**AGENDA
ZONING COMMITTEE
OF THE SAINT PAUL PLANNING COMMISSION
Thursday, October 22, 2009 3:30 P.M.
City Council Chambers
Third Floor City Hall - Saint Paul, Minnesota**

PLANNING COMMISSION STAFF REPORT

FILE # 09 203521

Tom Beach - MGM Site Plan Comments

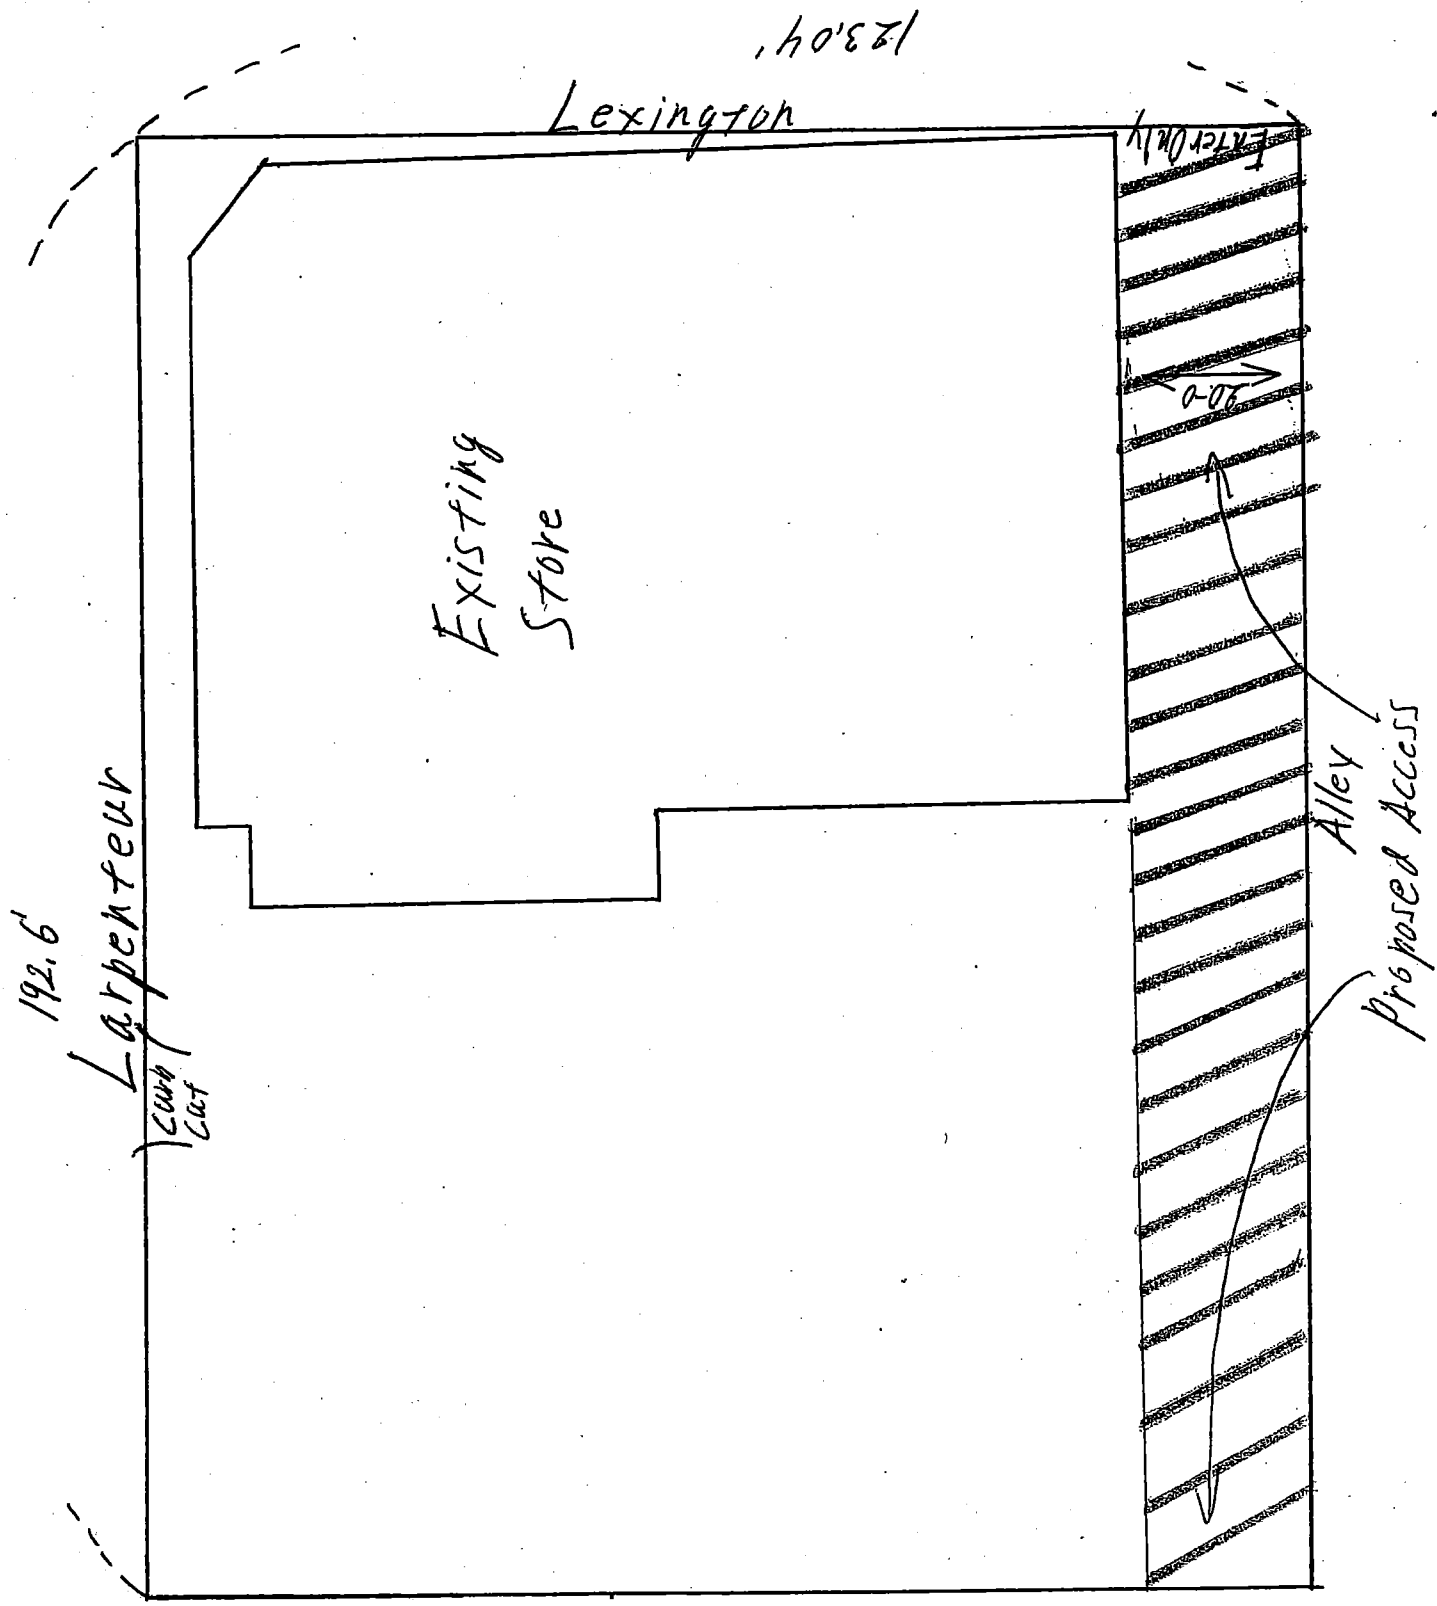
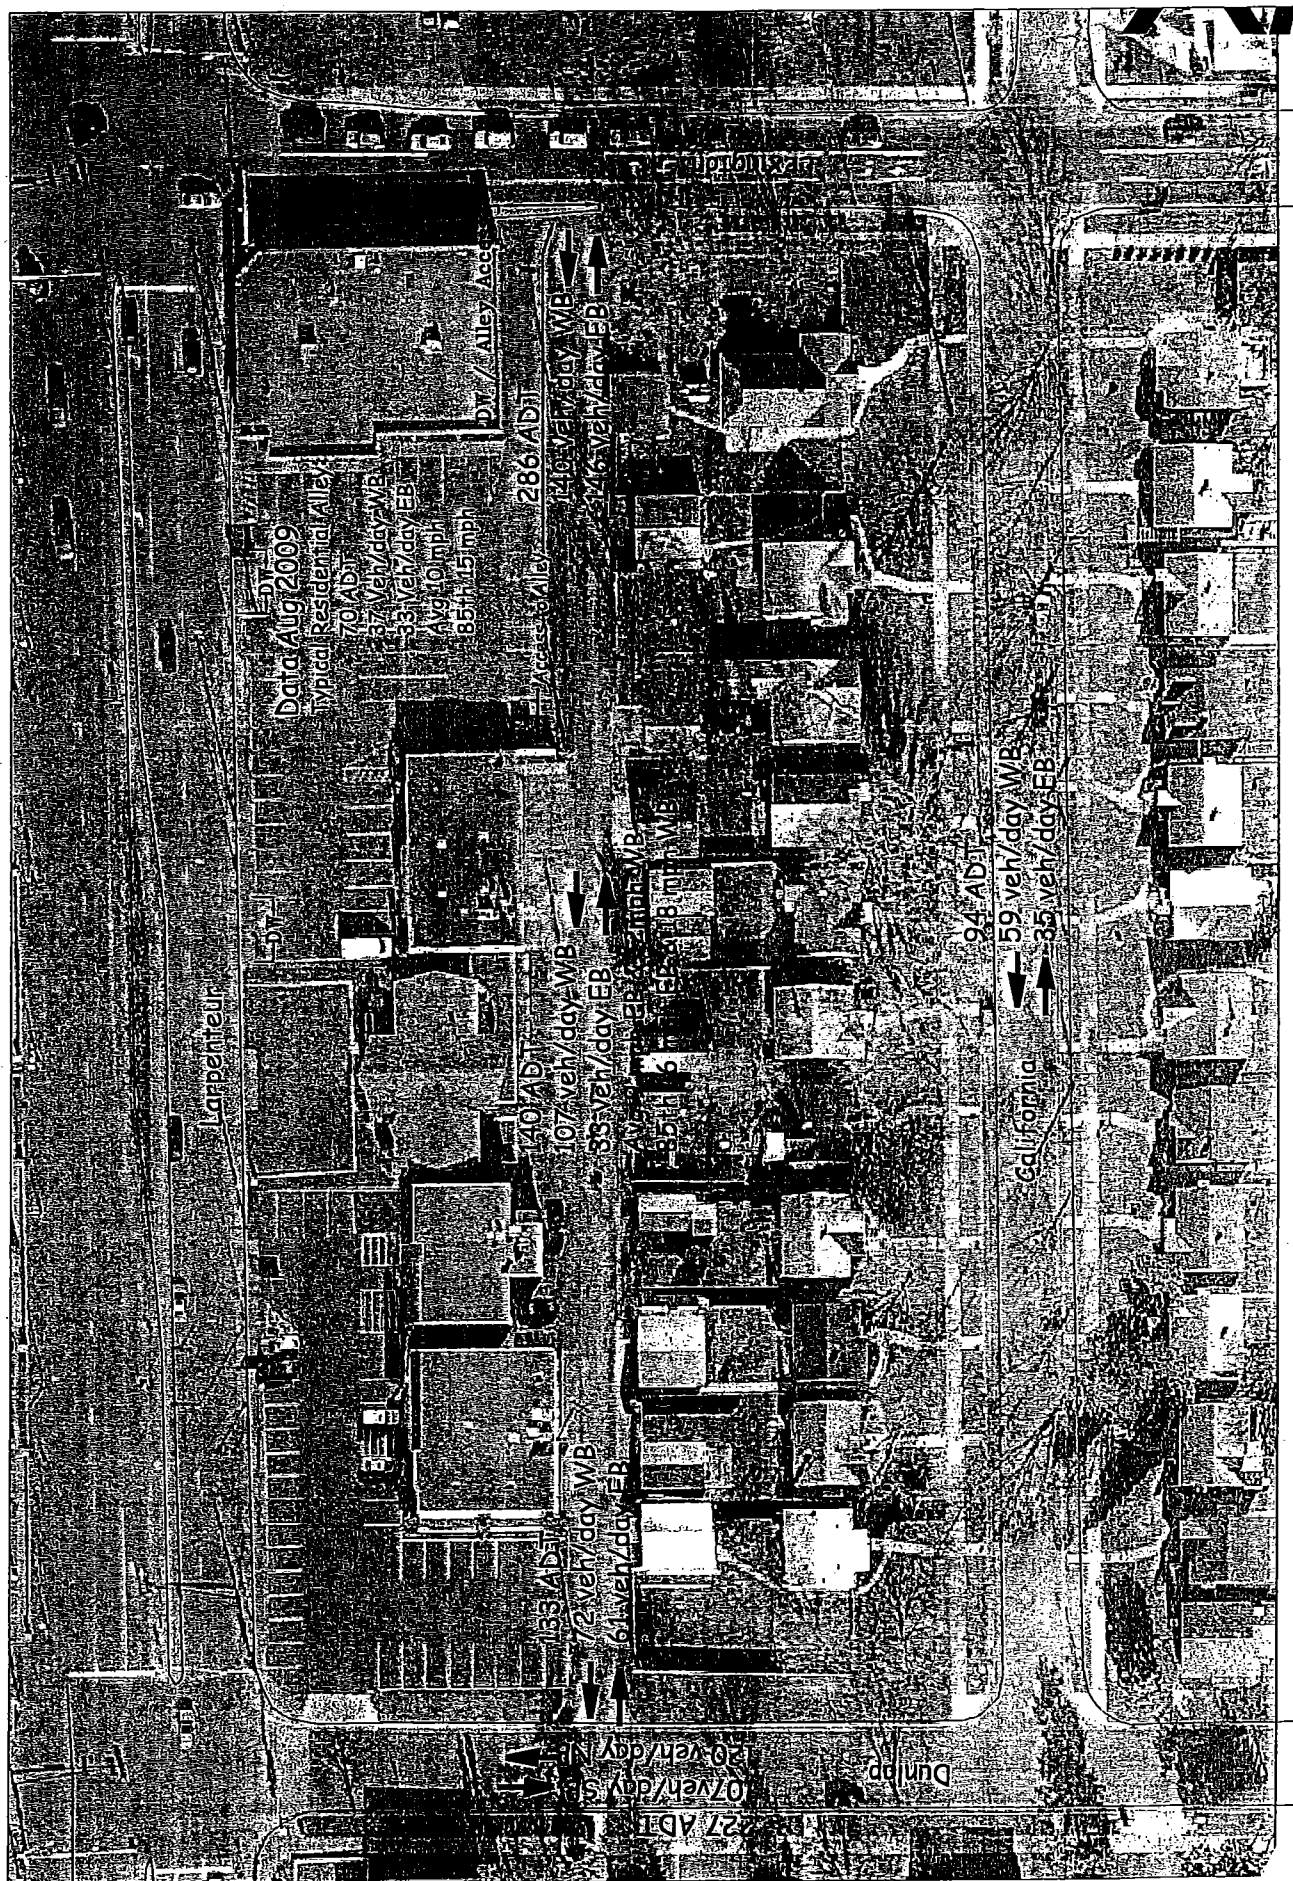
The site plan submitted by MGM Liquor provides no pertinent traffic information regarding access, accessibility or traffic safety for this site. All that was provided was a rudimentary sketch showing full access to the abutting alley at all points along the south boundary with the alley and evidently an undefined alley/driveway access along Lexington. It is presumed that no changes are being proposed internal to the parking lot or at the access points along Larpenteur.

To address this submittal we took a look at the site access including collecting some general volume and speed information surrounding the property.

The data collected shows the alley volumes are 2 to 4 times higher than a typical residential alley and actually has more traffic, in particular at the east end of the alley, than the adjacent local streets of California and Dunlap. Traffic volumes of a local street magnitude in an alley are not acceptable from a traffic management/ safety perspective as the design of an alley is narrower than a street with more limited lines of sight and a need for lower speeds to offset the potential for vehicle/vehicle conflicts with the limited sight. The open accessibility along the full length of the property allows traffic to enter the alley at any point along the alley with higher speeds aggravating the vehicle/vehicle conflict. In addition, it appears from the data that the property maybe experiencing some cutting through of traffic from Larpenteur eastbound across property to the alley which again is a traffic safety issue internal to the site and the public alley.

On the basis of the above we recommend denial of the site plan showing full access along the alley and the undefined driveway/alley access point onto Lexington.

1980 MGM site plan showing 8' privacy fence
along the alley

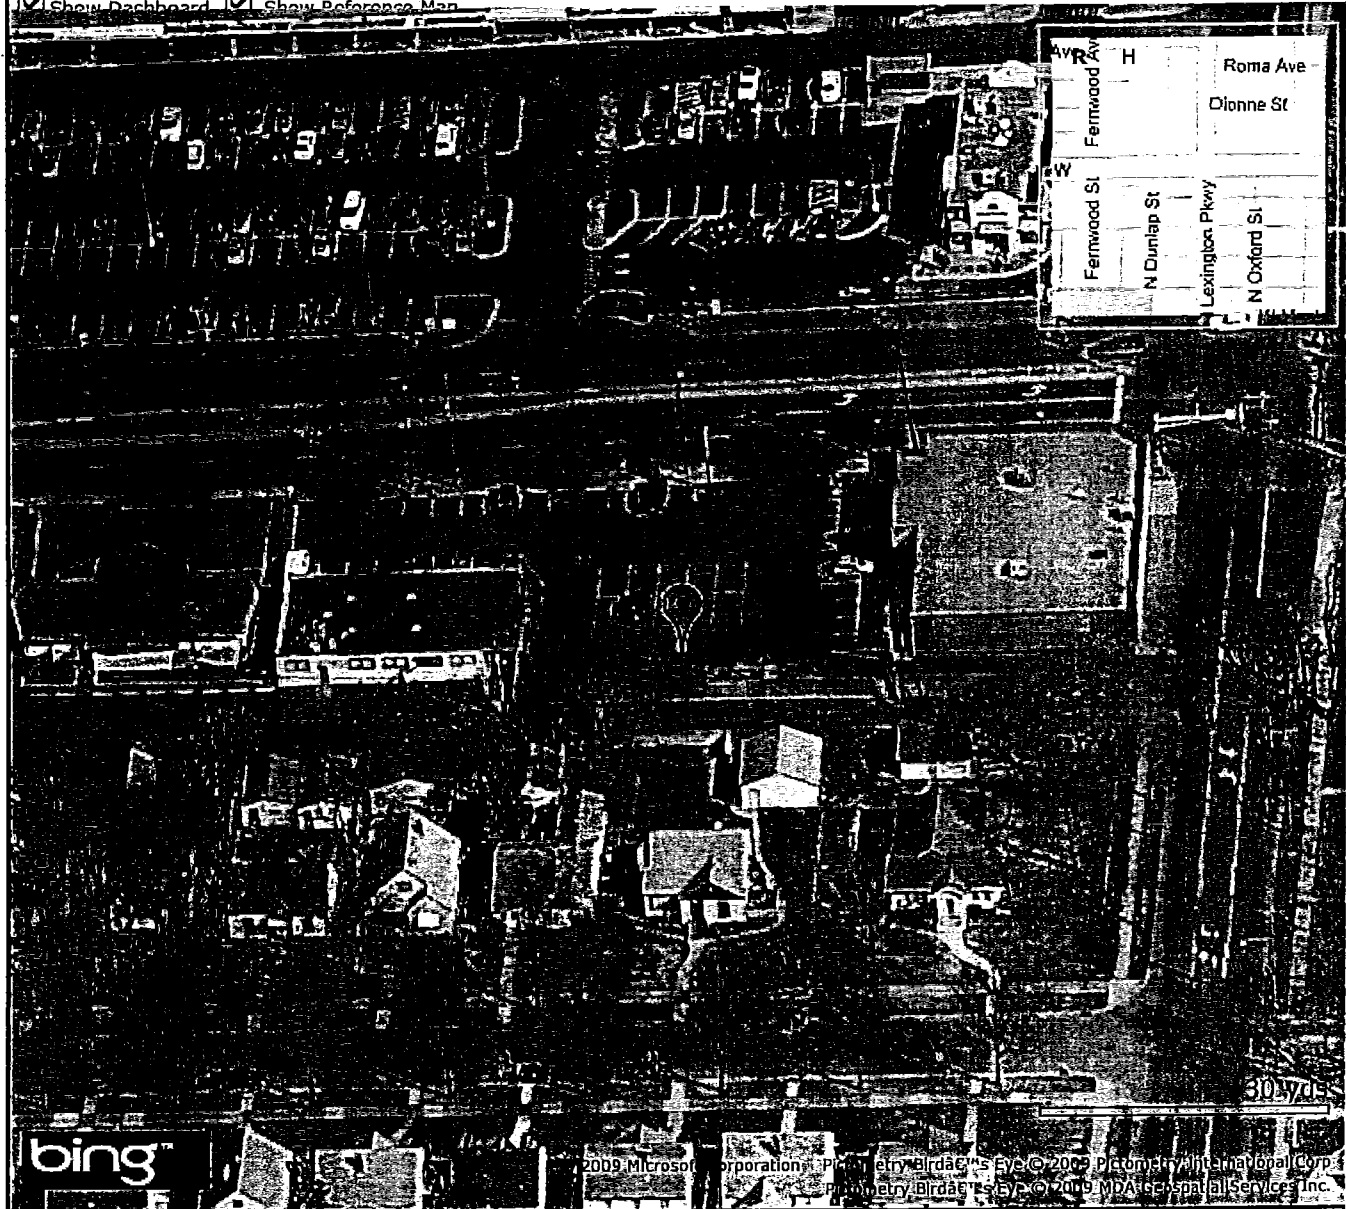
- The approved site plan shows an 8' high privacy fence along the south property line, between the MGM parking lot and the adjacent public alley. The fence prevented vehicular access between the MGM parking lot and the alley. The fence also provided a visual screen between the MGM parking lot and the residential property across the alley as required by Section 63.313 of the Zoning Code.

Restore the fence as shown on the approved site plan for the construction of this site dated June 18, 1980. The fence must be in place by July 14, 2009.
